ADDENDUM

PROJECT:	Grand Peaks Medical Clinic	ARCHITECT'S PROJECT NO:	1804
OWNER:	Grand Peaks Medical	ADDENDUM NUMBER:	1
BID DATE:	07.02.19	TIME:	2:00 p.m.
		ADDENDUM DATE:	06.21.2019

GRAND PEAKS MEDICAL CLINIC

T1.1

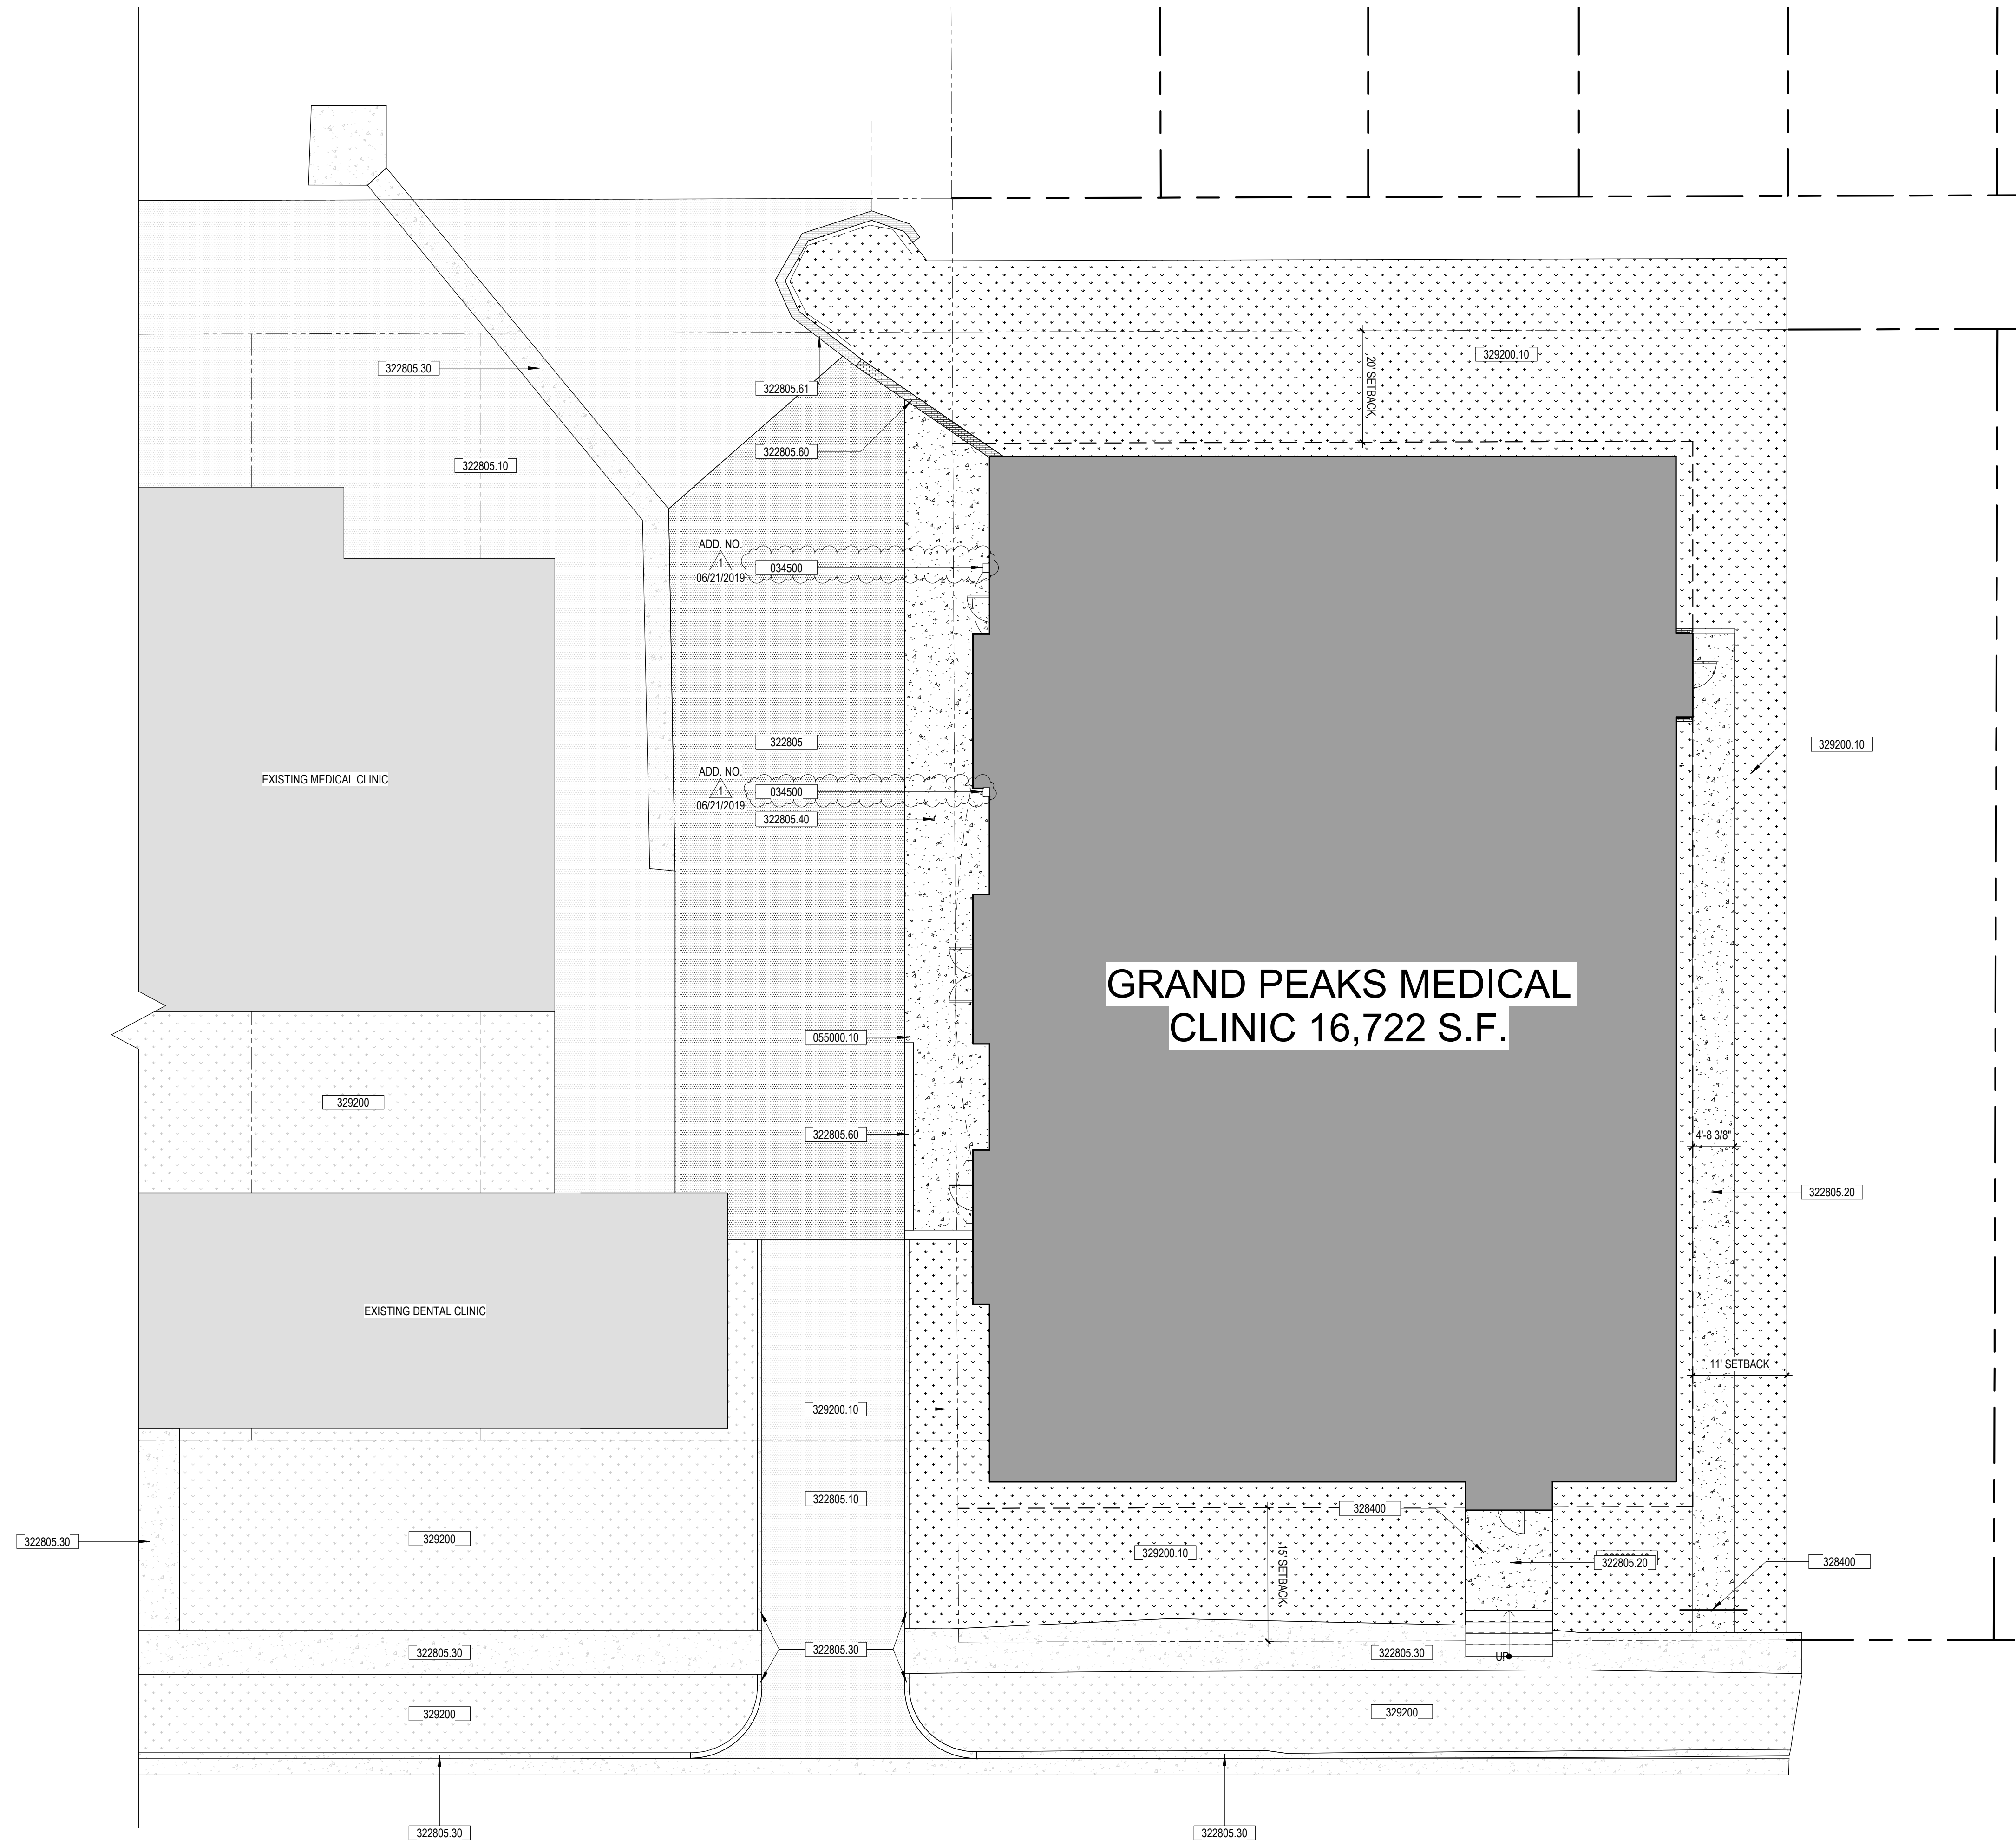
1. SHEET T1.1 – TITLE SHEET
 - a. Revise INDEX TO DRAWINGS – see attachment T1.1
2. SHEET AS1.1 – SITE PLAN
 - a. Add splash blocks and keyed notes to 1/AS1.1 OVERALL SITE PLAN – see attachment AS1.1
 - b. Add keyed note 034500 – see attachment AS1.1
3. SHEET A1.1 – GROUND FLOOR PLAN
 - a. Revise A1.1 GROUND FLOOR PLAN – see attachment A1.1
4. SHEET A1.2 – SECOND FLOOR PLAN
 - a. Revise A1.2 SECOND FLOOR PLAN – see attachment A1.2
5. SHEET A2.1 – BUILDING DETAILS
 - a. Add call out tagS to INTERIOR TRIM PACKAGE – see attachment A2.1
6. SHEET A2.2 – BUILDING DETAILS

12 P-LAM COUNTER DETAIL
 3" = 1'-0" A2.2

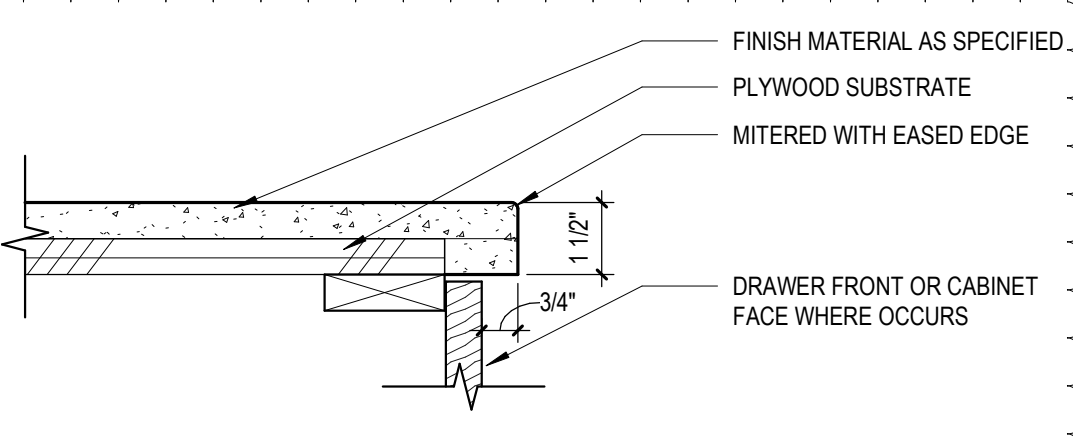
- a. Add detail 11/A2.2 STONE COUNTER DETAIL – see attachment A2.2
- c. Add detail 12/A2.2 P-LAM COUNTER DETAIL – see attachment A2.2
- 7. SHEET A3.1 – EXTERIOR ELEVATIONS

2 EAST ELEVATION
A3.1 1/8" = 1'-0"

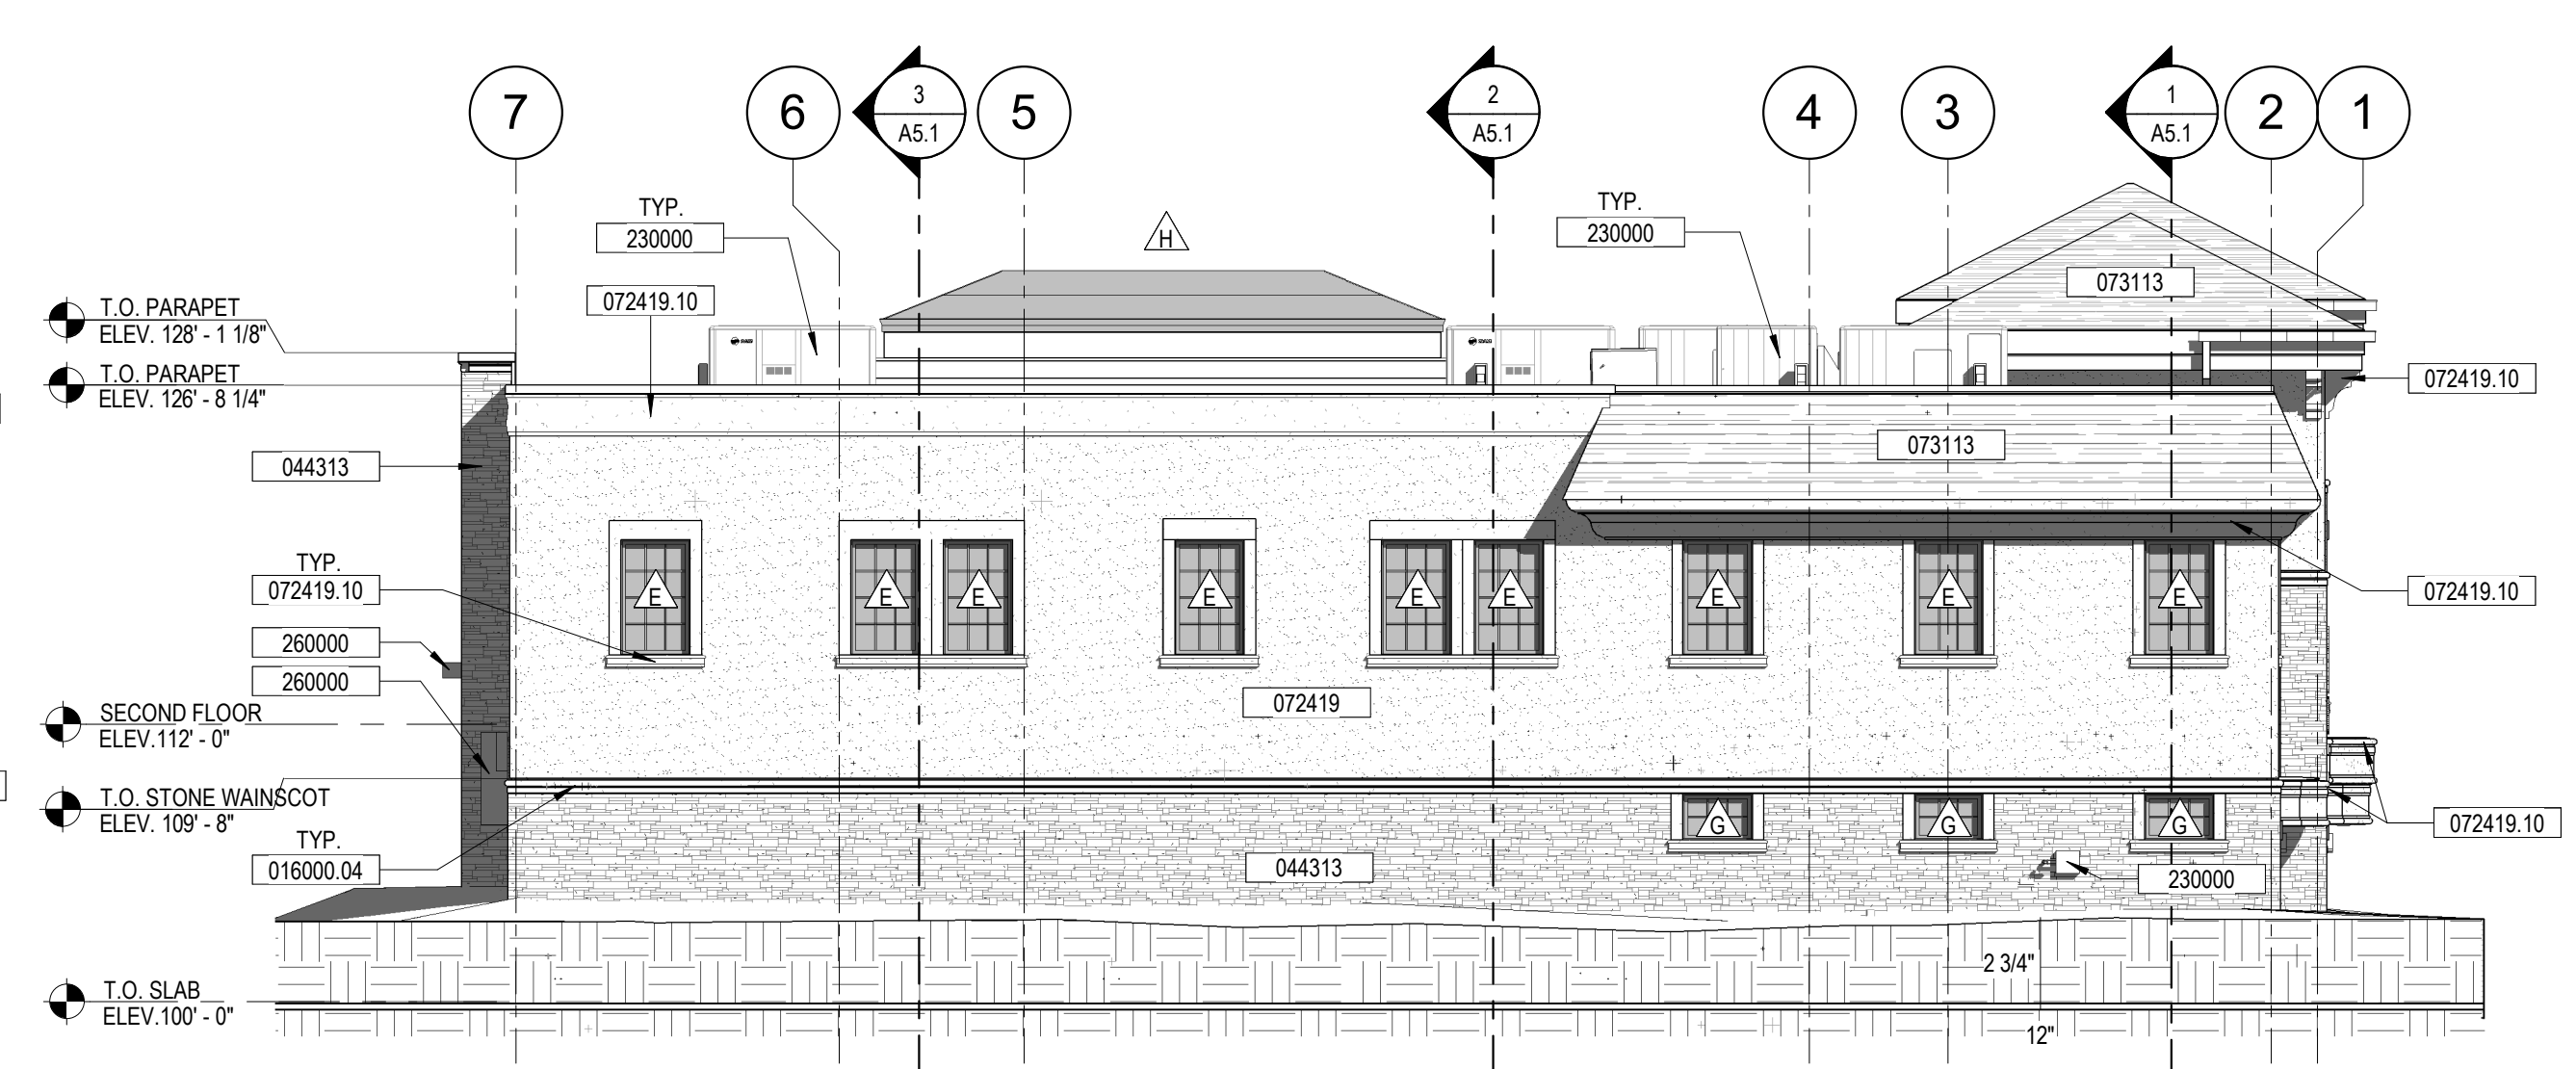
- a. Revise 2/A3.1 EAST ELEVATION – see attachment A3.1
 - b. Revise 4/A3.1 WEST ELEVATION – see attachment A3.1
- 8. SHEET A4.1 – ROOF PLAN
 - a. Add drawing 2/A4.1 LOWER ROOF PLAN – see attachment A4.1
